CITY OF MOBILE
THREE MILE CREEK GREENWAY TRAIL LIGHTING - SEGMENT 1
& JAPANESE GARDENS PARKING LOT LIGHTING

Project No. 2025-2045-01

ADDENDUM #2

LIGHTING PLAN

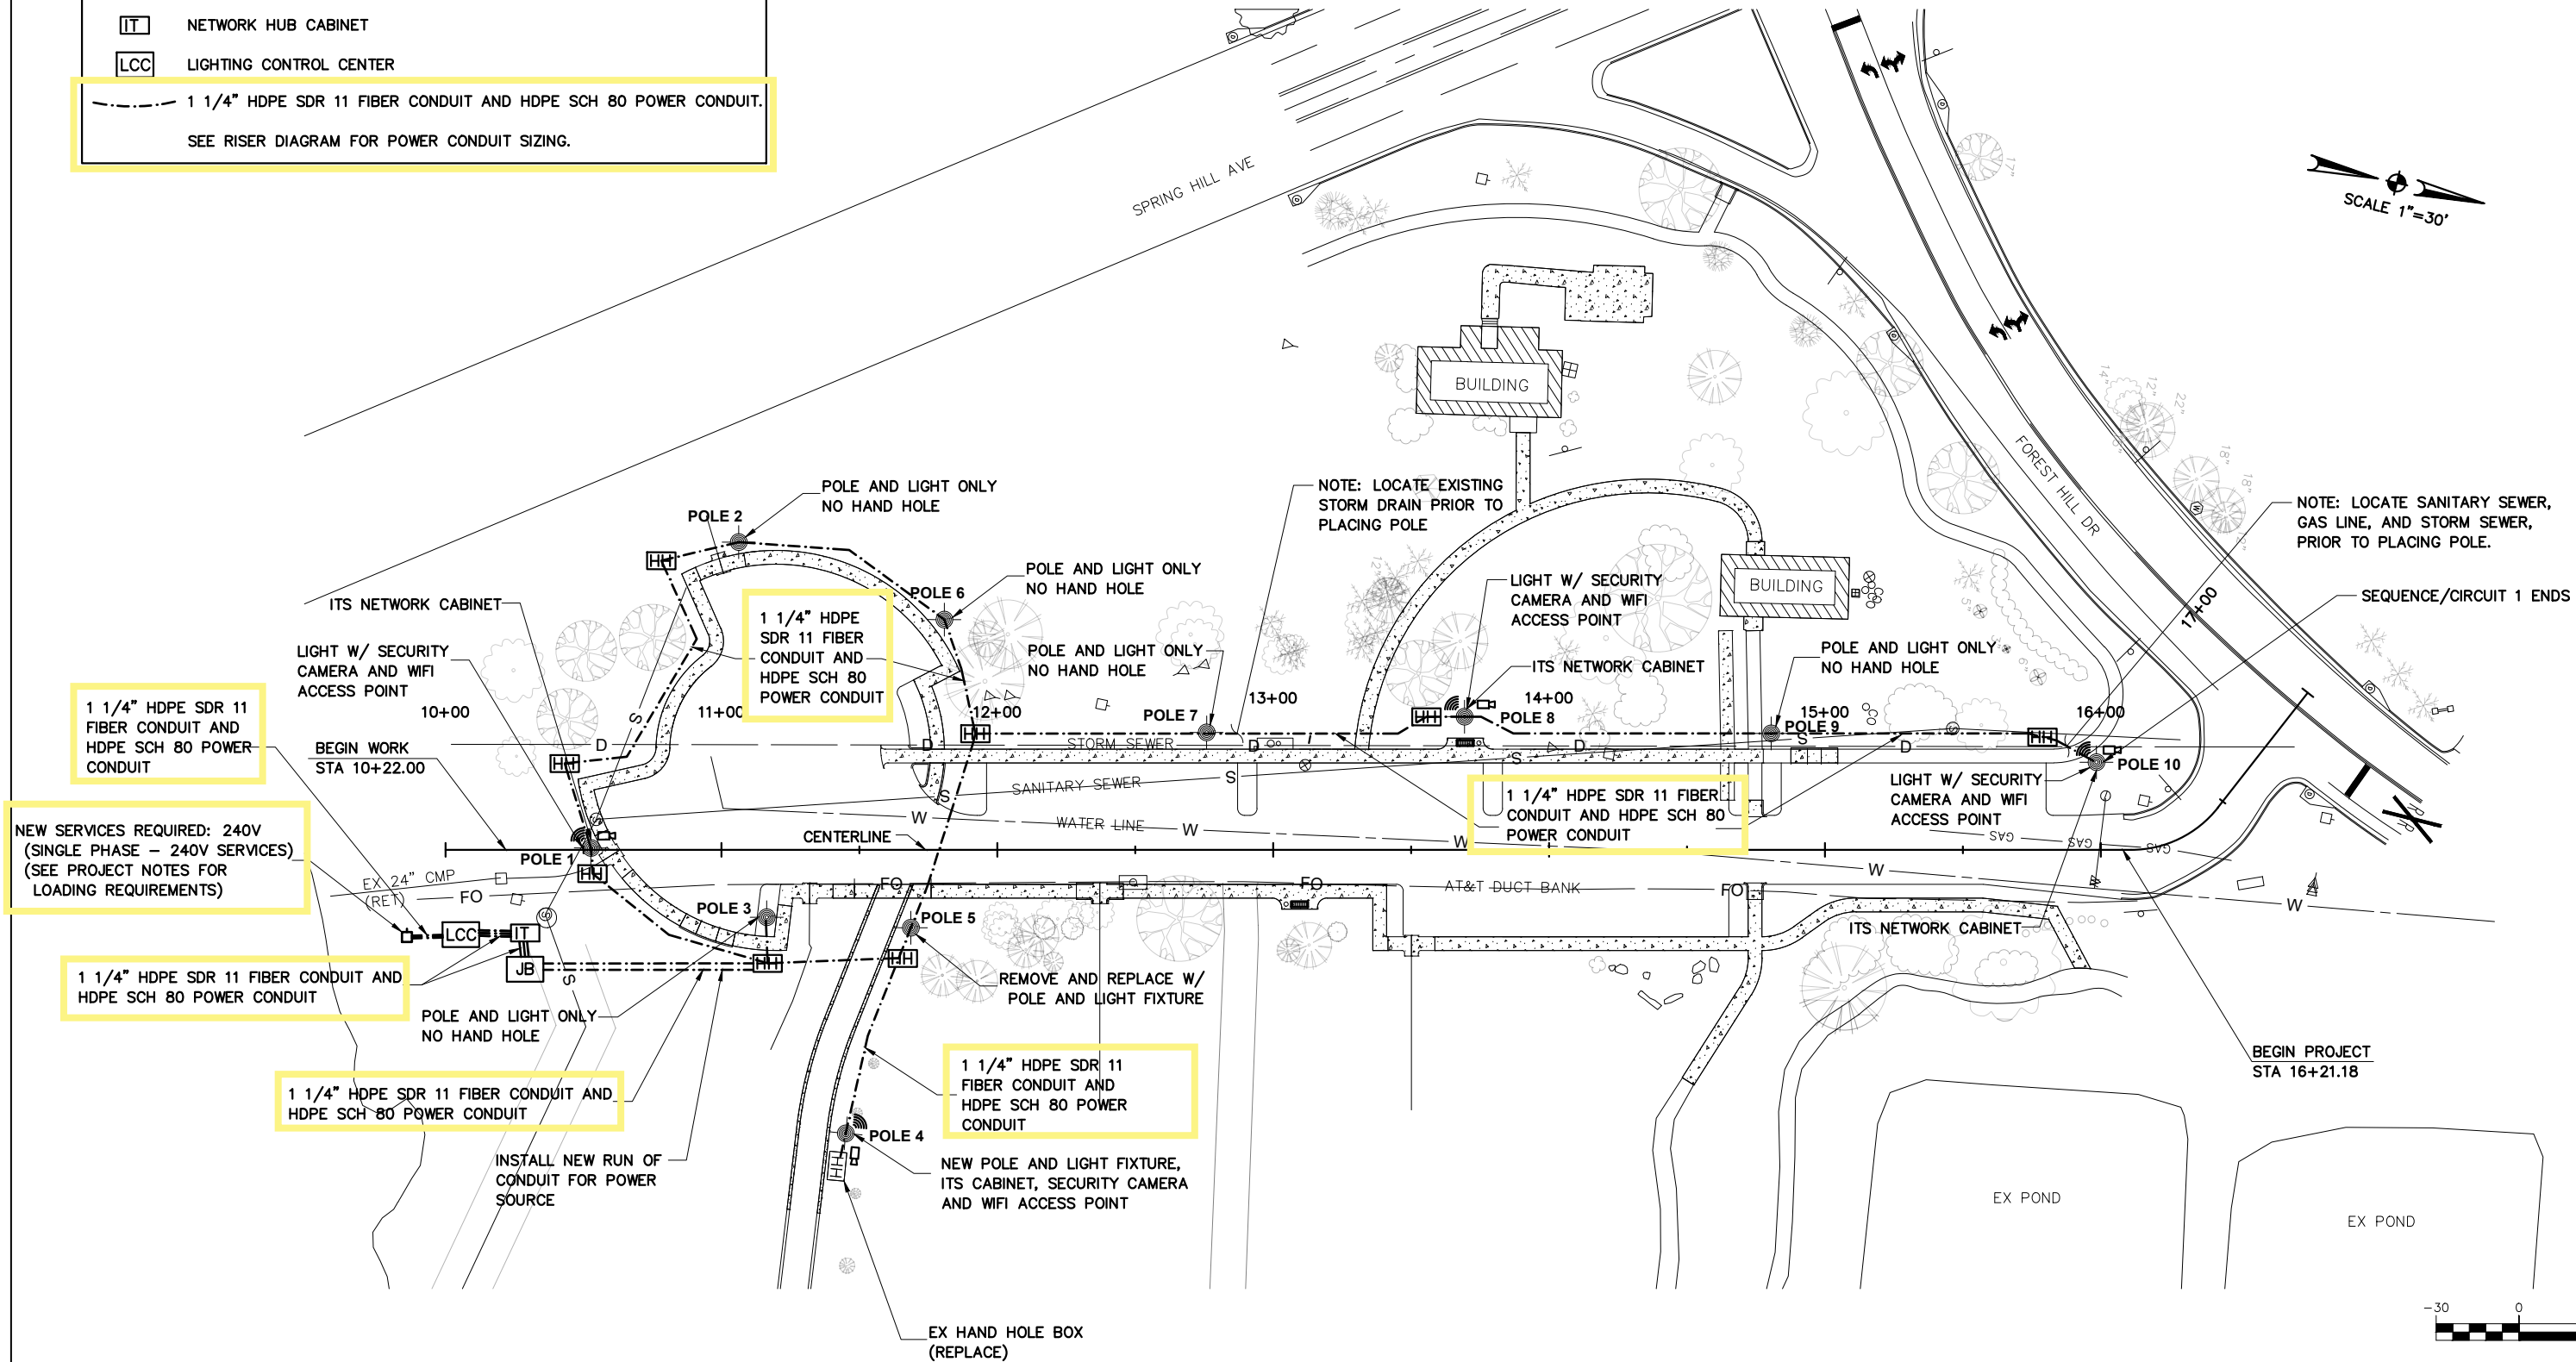
- Page 13 of 17, LIGHTING PLAN
 - Removed duplicate callout “SEQUENCE/CIRCUIT 2 BEGINS”.
 - Legend updated with, “1 1/4" HDPE SDR 11 FIBER CONDUIT AND HDPE SCH 80 POWER CONDUIT. SEE RISER DIAGRAM FOR POWER CONDUIT SIZING.”

- Six (6) callouts for Fiber and Power conduit updated to say “1 1/4" HDPE SDR 11 FIBER CONDUIT AND HDPE SCH 80 POWER CONDUIT.”
 - Updated callout for New Services Required to include “(SINGLE PHASE – 240V SERVICES)”

1 1/4" HDPE SDR 11 FIBER CONDUIT AND HDPE SCH 80 POWER CONDUIT.
SEE RISER DIAGRAM FOR POWER CONDUIT SIZING.

ELECTRICAL SITE PLAN

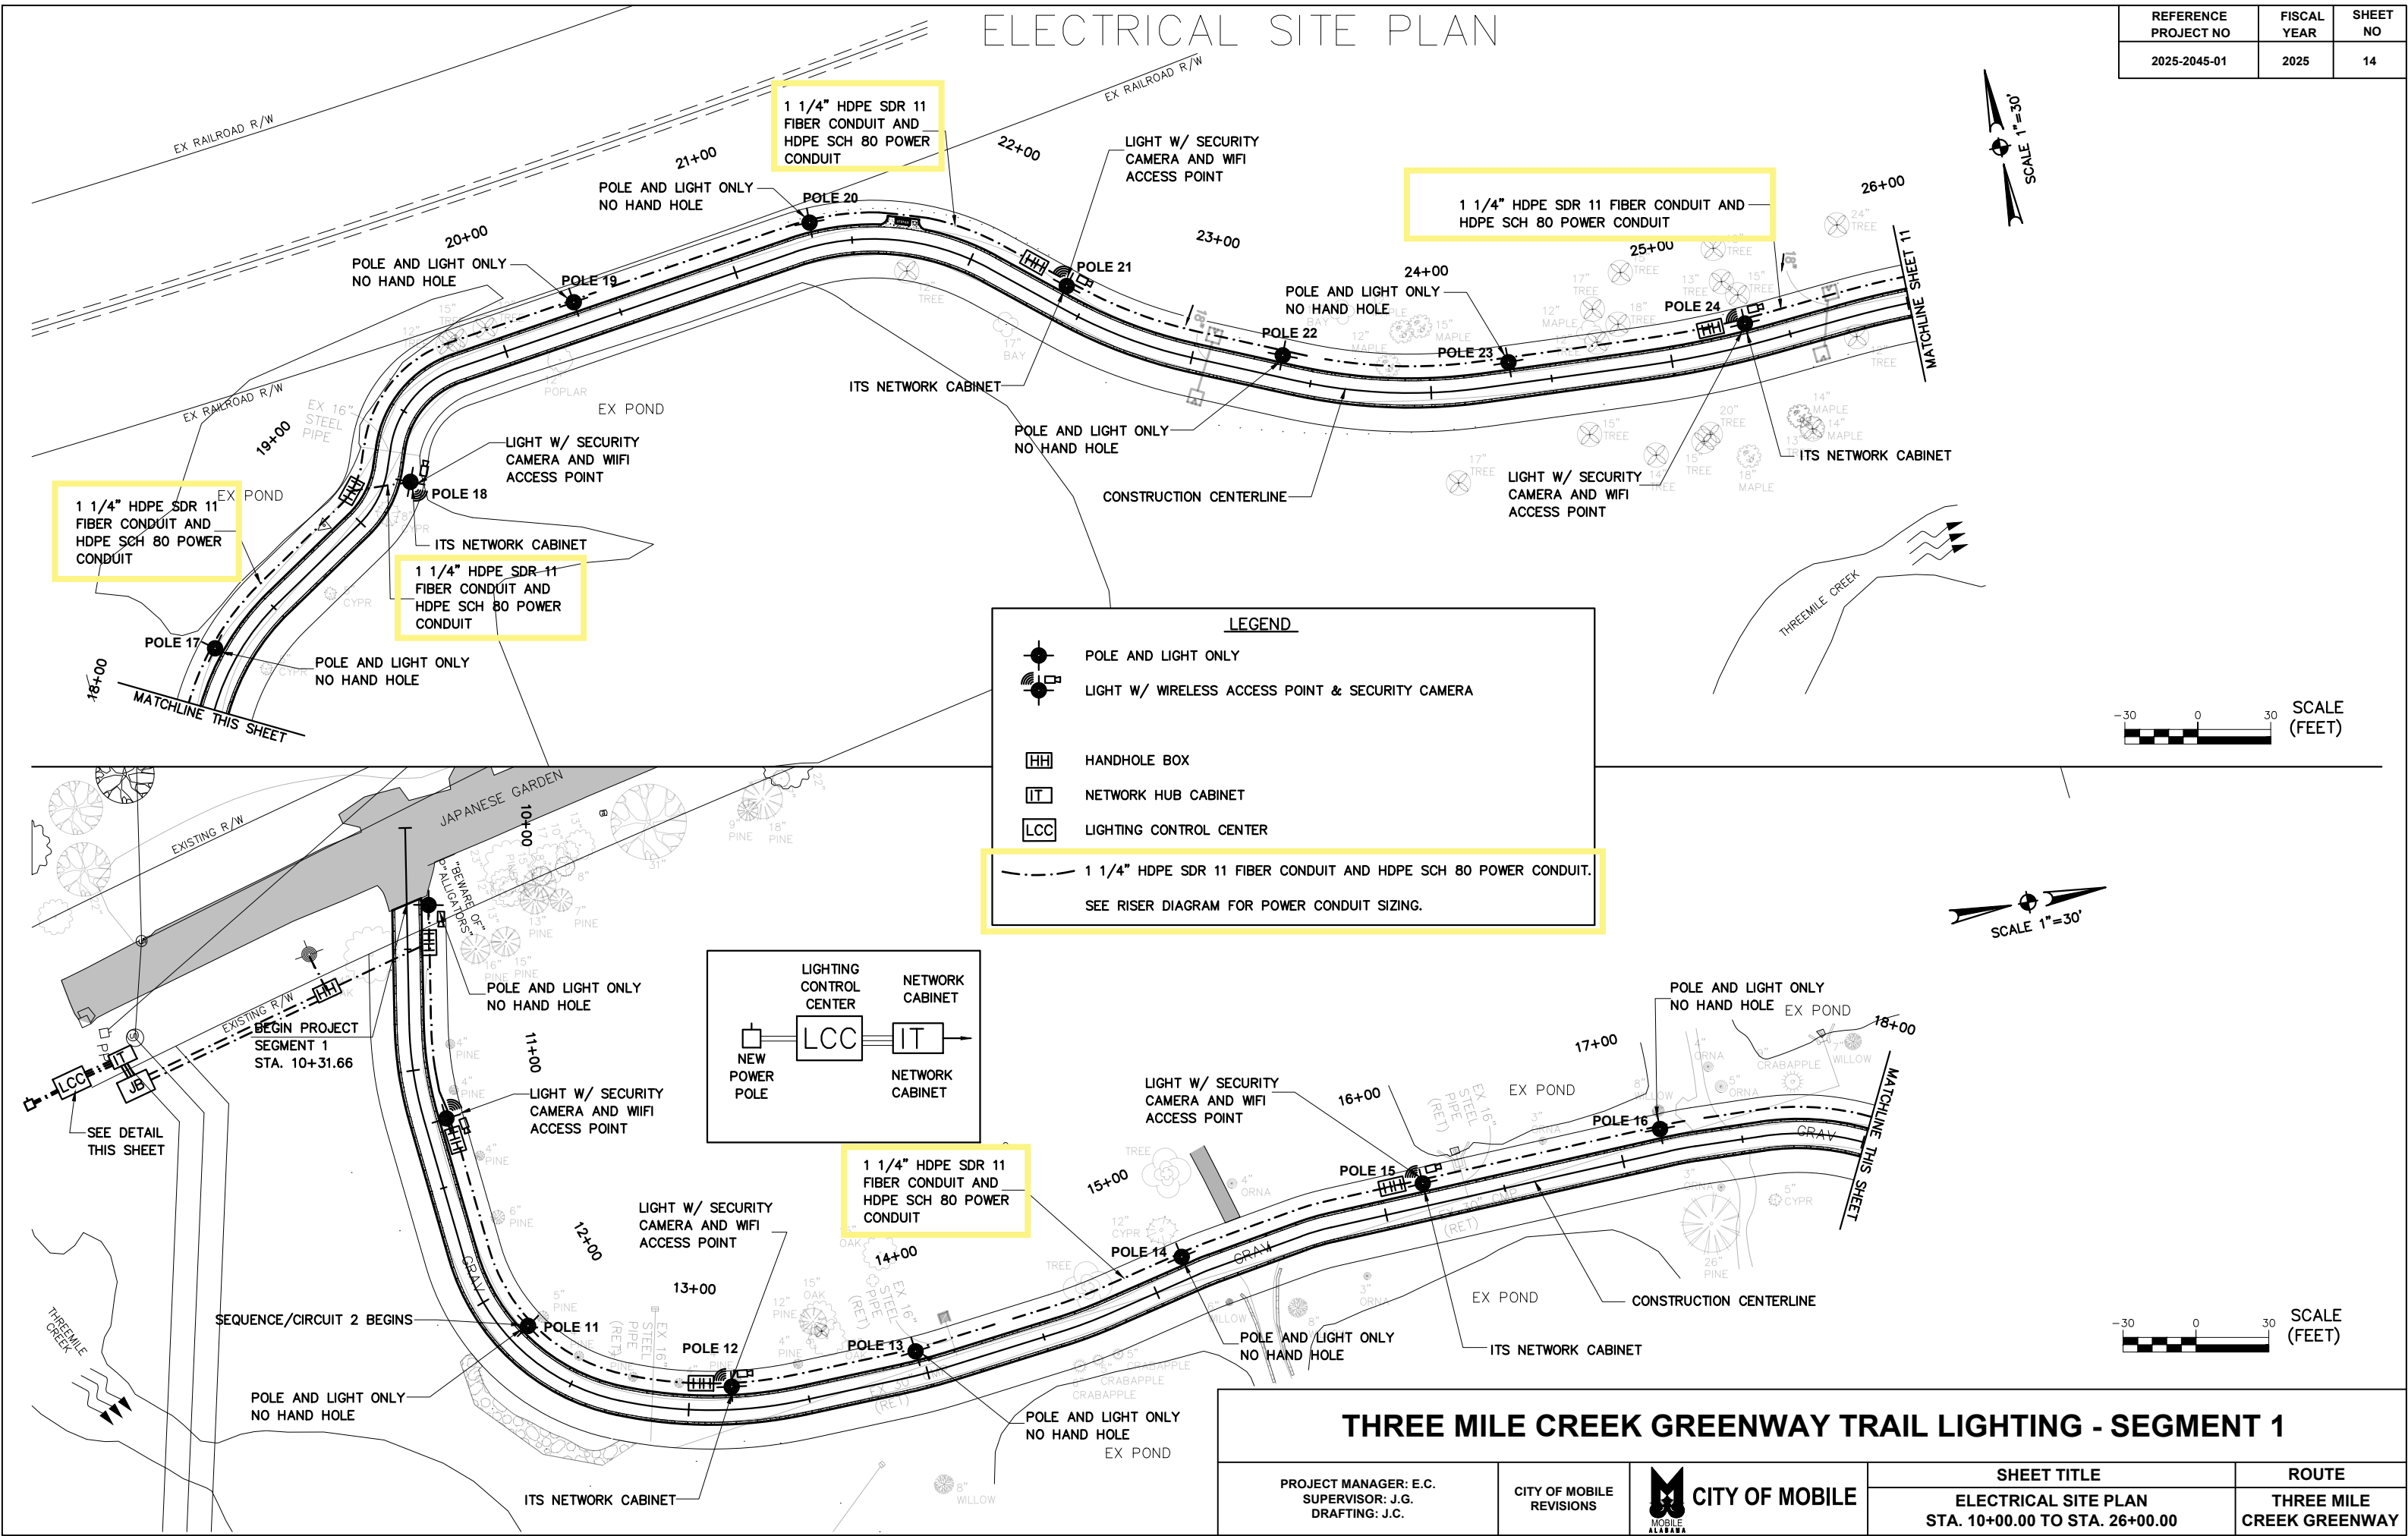
- Page 14 of 17, ELECTRICAL SITE PLAN 10+31.66 TO 26+00.00
 - Legend updated with, “1 1/4" HDPE SDR 11 FIBER CONDUIT AND HDPE SCH 80 POWER CONDUIT. SEE RISER DIAGRAM FOR POWER CONDUIT SIZING.”

- Five (5) callouts for Fiber and Power conduit updated to say “1 1/4" HDPE SDR 11 FIBER CONDUIT AND HDPE SCH 80 POWER CONDUIT.”
- Page 15 of 17, ELECTRICAL SITE PLAN 26+00.00 TO 42+00.00
